UNITED STATES
NUCLEAR REGULATORY COMMISSION

DOCKET NO. 50-445-OL
50-446-OL

MEETING TO DISCUSS
TECHNICAL REVIEW TEAM STAFF FINDINGS - COMANCHE PEAK

Friday, January 17, 1985

Figure 1. Hardware Examples

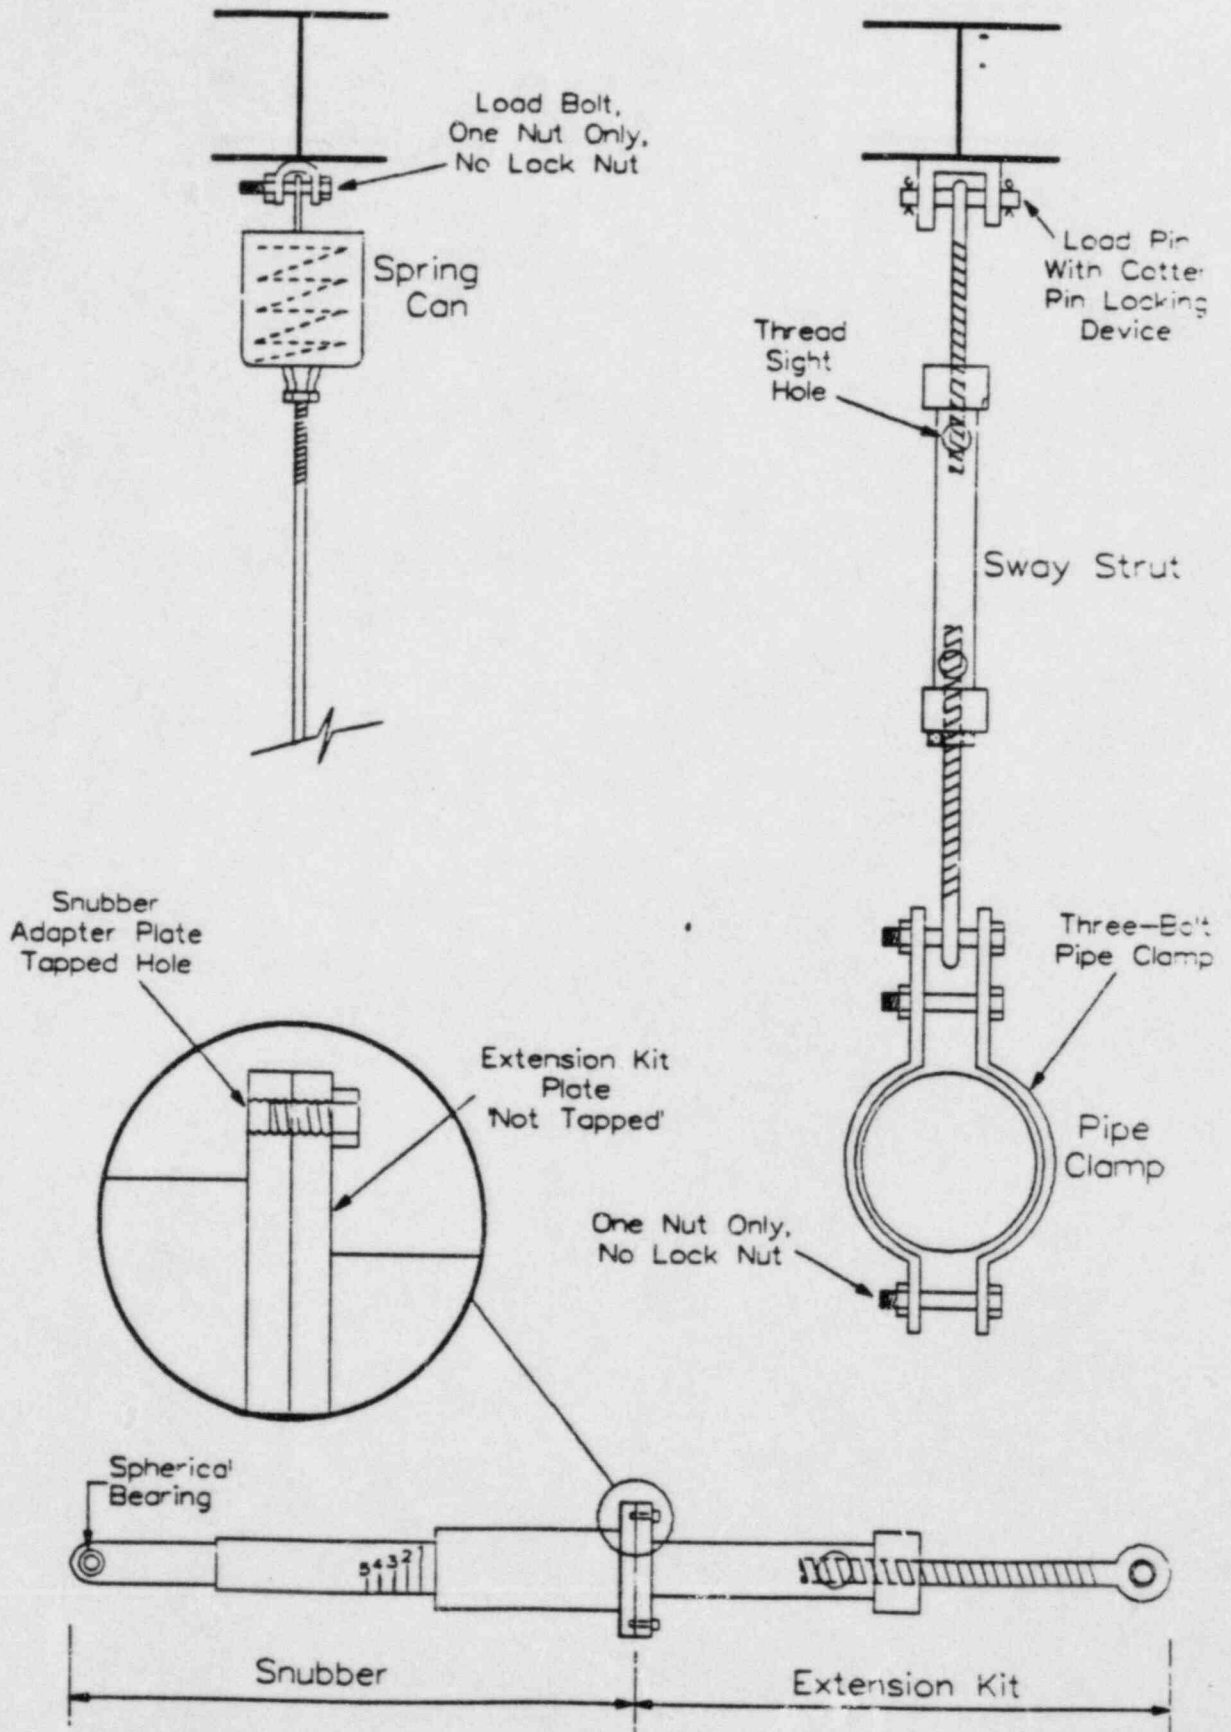
- Undersize welds
- Weld undercut and porosity
- Weld insufficient fill and surface
- Grinding of base metal material
- Excess welds not shown on drawing
- Absence of QC weld buy-offs
- Insufficient thread engagement
- Absence of locking devices
- Minimum edge distance violation
- Excessive gap in spherical bearing interfaces – strut and snubber
- Shock arrester model numbers do not match drawings

- Component support bolt holes out of location
- Spherical bearing contamination
- Thread engagement not verified
- Pipe clamp halves not parallel
- Pipe clearance with supports out of tolerance
- Loose pipe clamp locknuts
- Snubber/sway strut misalignment
- Snubber cold set out of tolerance
- Snubber orientation not on drawing
- Electrical hanger welds not on drawing
- Beam stiffeners not shown on drawing
- Material IDENTIFICATION LACKING
